Name Of Dam: TOMS CREEK DAM
Location: WISE COUNTY, VIRGINIA
Inventory Number: VA. NO. 19510

PHASE I INSPECTION REPORT

NATIONAL DAM SAFETY PROGRAM

PLATE No. 2

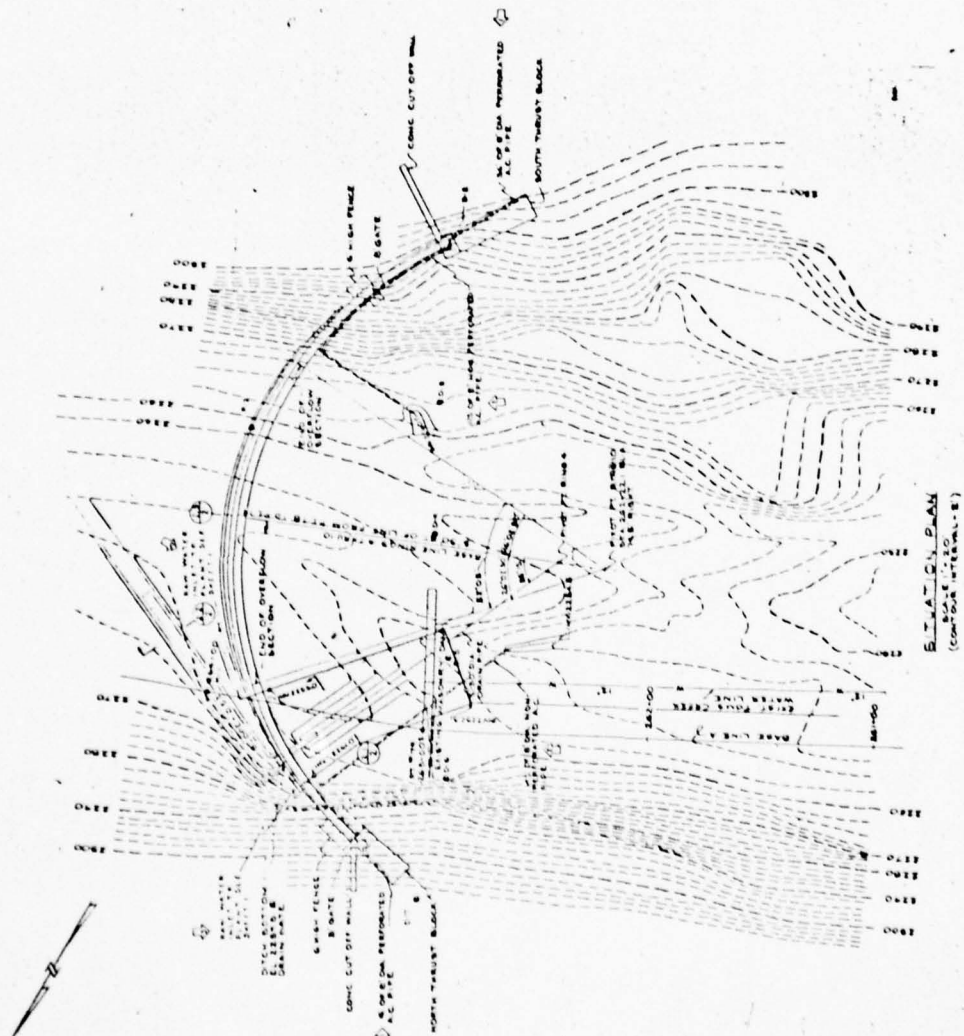
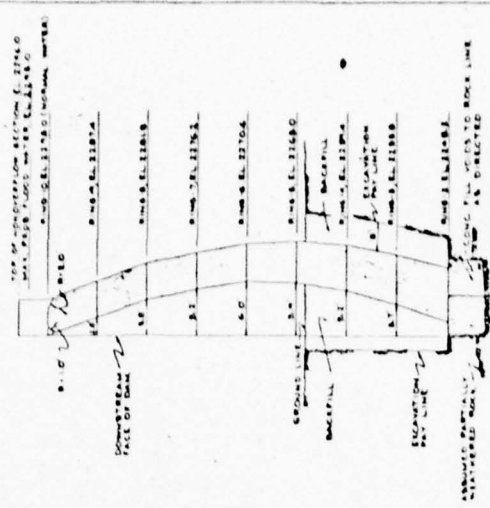
Referring to Plate 2, Appendix I, abandoned mine shafts exist approximately 150 ft below ground surface and immediately upstream from the structure.

Plate 2, Appendix I provides the approximate location for an interconnecting series of abandoned coal mine shafts. These shafts are shown to exist 150 ft[±] beneath the ground surface adjacent to but not under the dam, and beneath the reservoir. The locations shown are presented as accurately as could be determined from mine maps reviewed by the designer. The presence of the mine shafts has not apparently caused any problems.

WATER TREATMENT PLANT DOWNSTREAM
(NOTE CARETAKER'S HOME, ARROW)

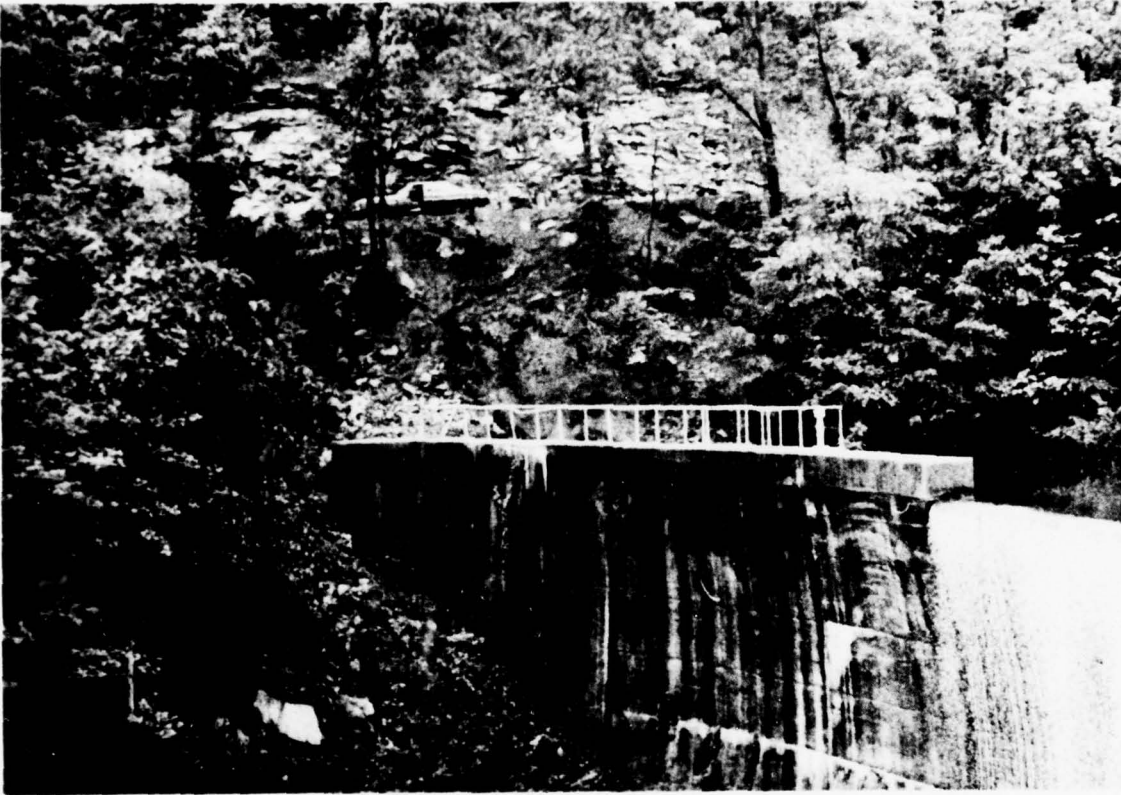
1.2.4 Hazard Classification: The dam is located in a rural area; however, based upon the location of a home and water filtration plant approximately 300 ft downstream (See Photo 1, Appendix II), and the industrial development and several homes within 2 miles downstream of the dam, the dam is assigned a "significant" hazard classification. The hazard classification used to categorize a dam is a function of location only and has nothing to do with its stability or probability of failure.

VIEW OF RIGHT ABUTMENT WHERE BOLDER
WASHED OFF ROAD ONTO WALKWAY (NOTE
BENT HANDRAIL)

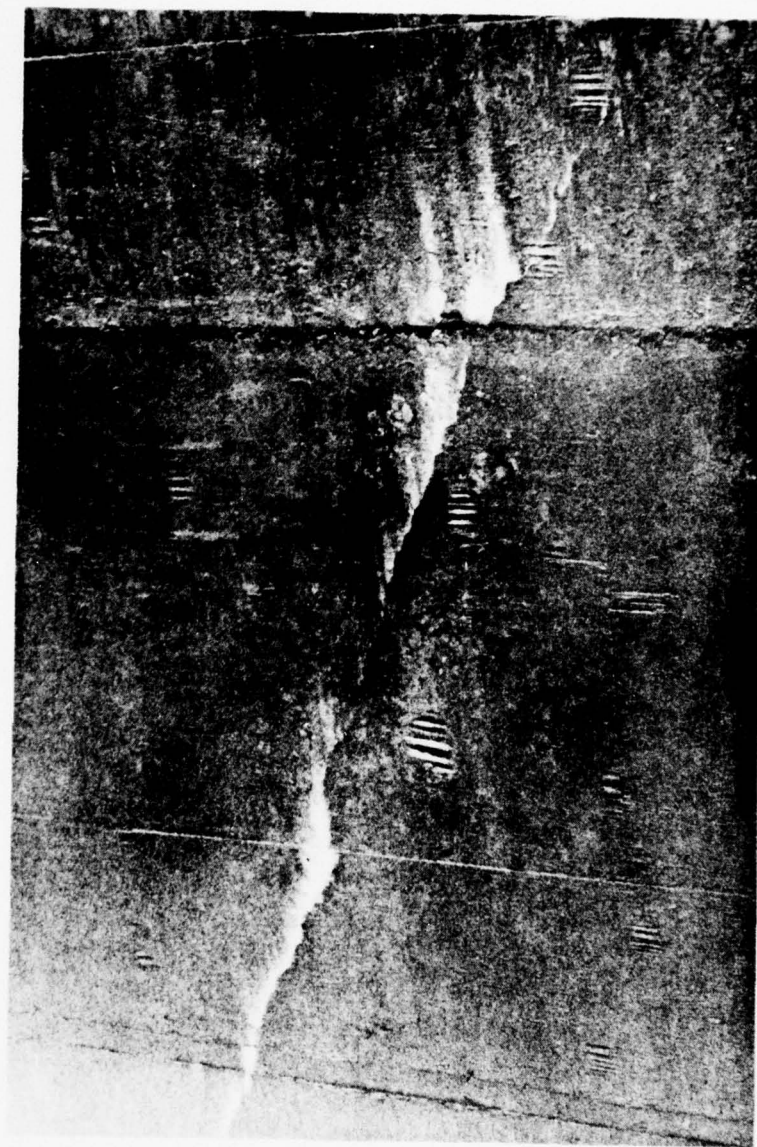
A small area directly above the contact of the dam and right abutment is eroding due to runoff water from a 30 inch CMP highway drain (See Photo No. 2, Appendix II). Erosion is occurring in the form of embankment sloughing.

The steep slopes which form the abutments were generally considered safe and stable at the time of investigation. One area of concern does exist along the upstream side of the right abutment. After construction of the dam the highway department placed a corrugated metal pipe beneath Route 652 to divert drainage from the north side of the road into the reservoir (to the right and above the bent handrail, Photo 2, Appendix II). Considerable erosion and sloughing directly related to the pipe have since occurred. In one instance during a period of heavy runoff, a large block of rock fell and damaged a section of handrail (Photo 2, Appendix II). The location of this drain pipe is detrimental to the normal operation

7.2.3 The drainage pipe located above the right abutment should be relocated. Slope erosion associated with outflow from the pipe has already caused minor damage and we recommend it be relocated within the next six months, as to prevent future damage.
